INDEPENDENT REVIEW OF HAMPSTEAD HEATH PONDS PROJECT

Data request to Atkins, 28/10/14 – Final status 26/11/2014, including other info

HHPP RFI 1 Consequence Assessment

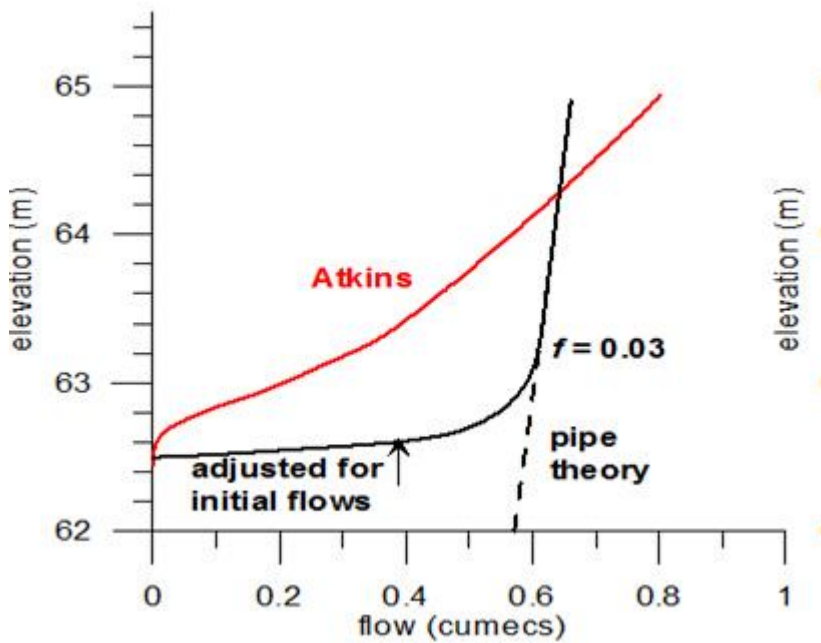
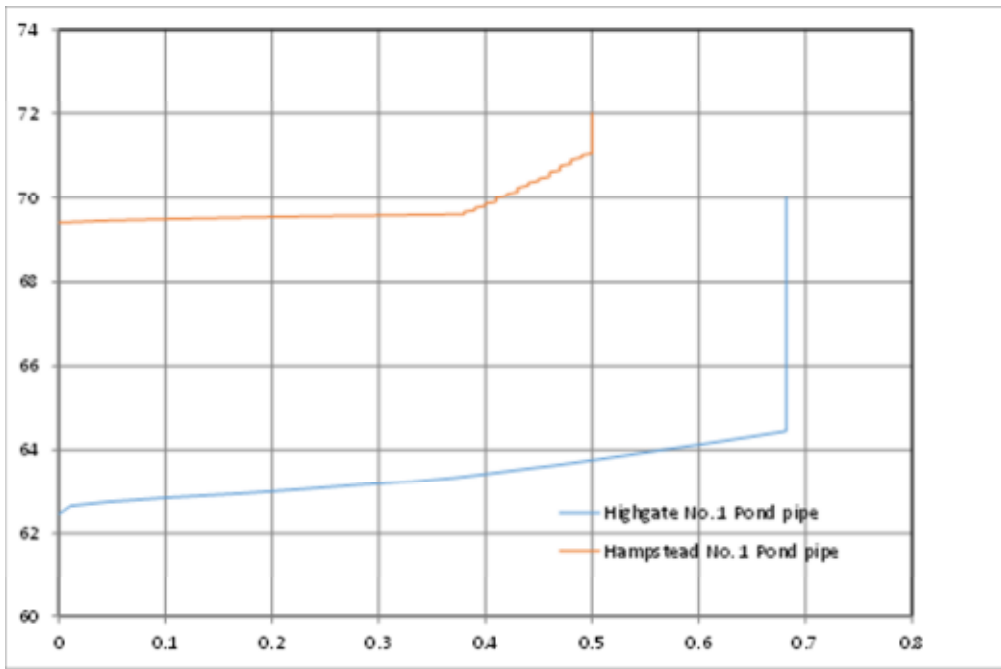
We have been asked to include in our review, comments received from Brookfield Mansions Ltd, which includes a paper from Professor Rushton regarding the overflow from Highgate No 1. The comments do include a number of misinterpretations which are adequately dealt with in Joanne's email to Jonathan Markwell of 21st October. However, I do have a query regarding Professor Rushton's paper. In it, he presents a graph showing the Atkins rating curve for the Highgate outlet pipe (in red below)

Where is this data from? It does not match the rating curve you sent me (below left) which does match quite well with Prof Rushton's rating curve (below right)?

The rating curve data used by Professor Rushton was taken from a workbook of answers to questions asked by one of the stakeholders who lives at Brookfield Mansions immediately downstream of Highgate No.1 Pond. (See attached file). We believe that Professor Rushton is assisting this particular resident.

Overflow from Highgate No 1

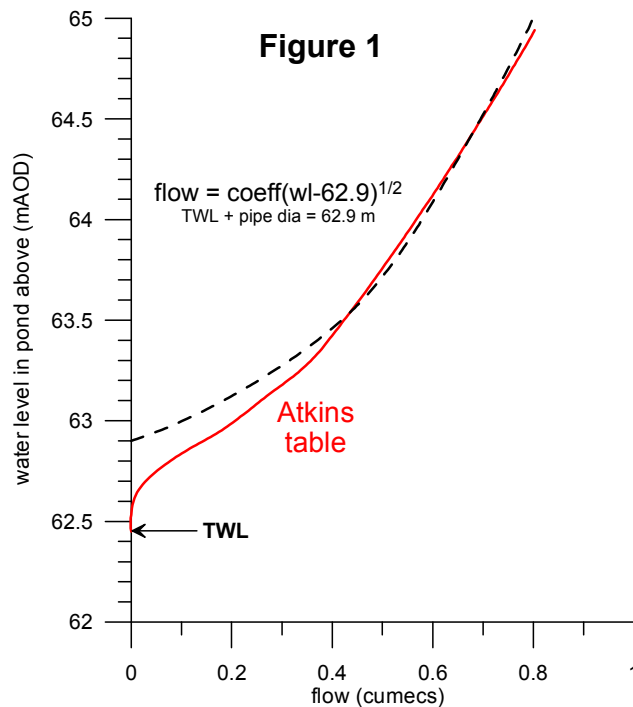
Comments on 03/10/2014 by Professor K R Rushton, PhD, DSc, CEng, MICE, MCIWEM.

The full line in the above graph is a plot of the flow through the overflow pipe from HG1 according to Atkins' calculation. The broken black line is my attempt to match part of the curve using an equation of the form head difference raised to the power 0.5. Apart from the early stages, the curves are not very different although the head for zero flow is 62.9 m rather than TWL of 62.5 m in Atkins' values. Nevertheless, it appears that Atkins have used some form of orifice equation where the flow equals the square root of the head difference between the water level in HG1 and the elevation of the inlet to the overflow, but with some adjustment for lower head differences. The general form of the orifice equation is

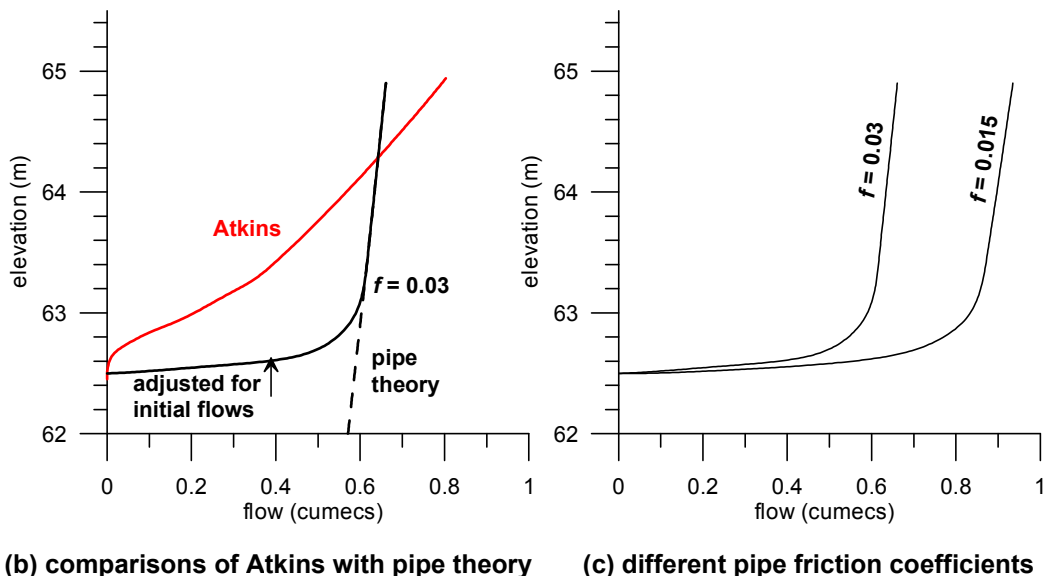
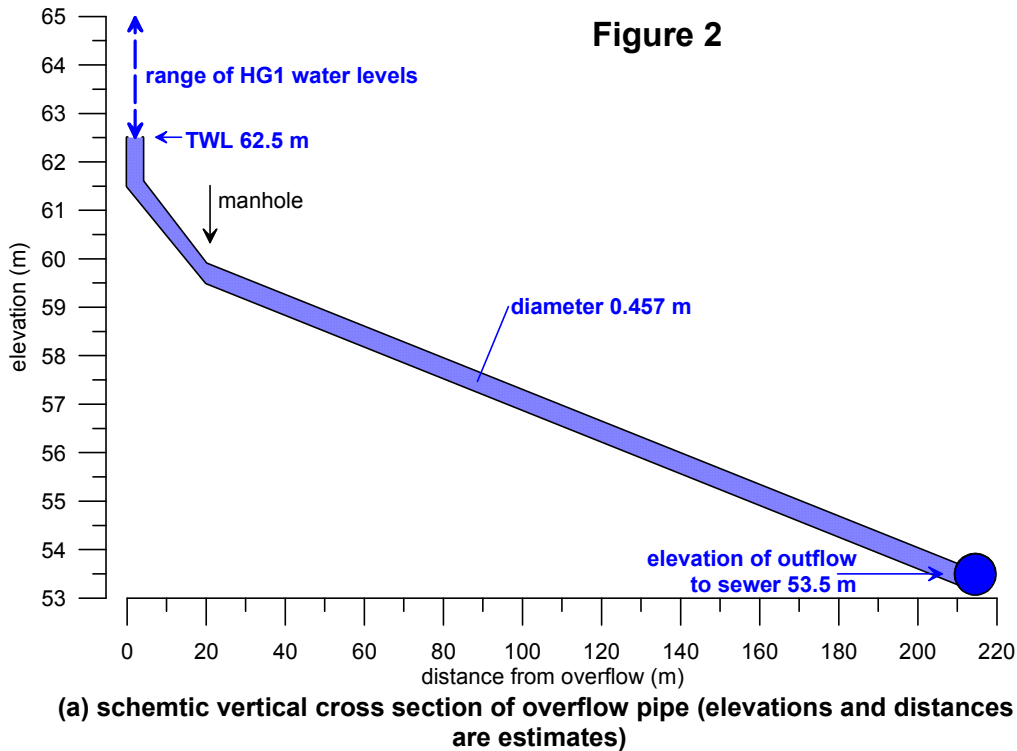
Figure 2(a) illustrates the probable layout of the overflow pipe (elevations and lengths need to be confirmed). Inflow occurs from HG1, outflow occurs to a sewer; for the initial calculations the sewer is assumed to be running half full. The difference in elevation between the water level in HG1 and the outflow to the sewer determines the flow through the overflow pipe.

Assuming $d = 457$ mm, $f = 0.01$ to 0.07 try 0.03, $l = 210$ m, outflow head = 53.5 m
head when inflow starts = 62.5 m so $h_f = 62.5 - 53.5 = 9.0$ m, $Q = (0.345)^{1/2} = 0.59$ cumecs
when head = 64.9 m, $h_f = 64.9 - 53.5 = 11.4$ m hence $Q = (0.437)^{1/2} = 0.65$ cumec

Figure 2(b) also contains a plot of the relationship calculated by Atkins. The curves exhibit significant differences, although the maximum flows are of similar magnitude. Of special significance is the relatively small difference in discharge for pipe flow over the range of water levels in HG1 (apart from the initial 0.5 m when the pipe is not flowing full of water).
